## SERVICE BULLETIN

To: Agencies servicing RiceMaster rice cookers

Models affected: serial numbers with "E" prefix with manufacturing code 06-04 or lower

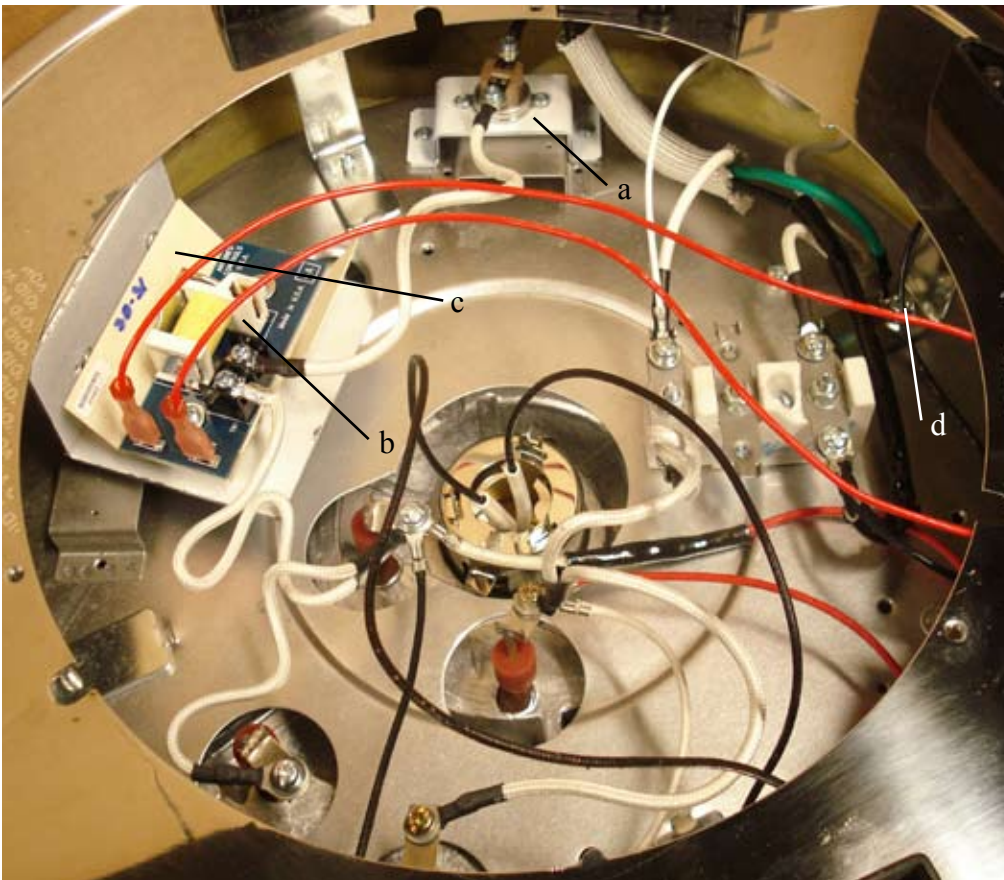
Some electronic RiceMaster rice cookers may fail after some use:

1. The female spade connectors may become loose after repeated heating. The loose fit causes poor conductivity and excessive heat which may melt the high limit control(a) or relay (b).
2. It has been determined the in-line fuse on the power cord may be removed.

1. When replacing the high limit(a), screw the connectors onto the terminals.
2. Install the heat shield(c) as shown when replacing the relay(b). This acts to keep the relay and its wiring cooler. We have had excellent results with this arrangement.
3. Relocate the green ground wire (d) to the body gusset screw. Secure with a lock washer and nut. The new position keeps the wire cooler which is better for the wire insulation.
4. Remove the fuse within an insulating sleeve on the black power cord.

photo letter	part no.
a	56845
Hi limit controller with <b>ring terminal</b> connectors	
b	57179
Relay (installation of Relay Heat Shield required)	
c	57178B
Relay Heat Shield	
d	n/a
relocate ground wire to this position
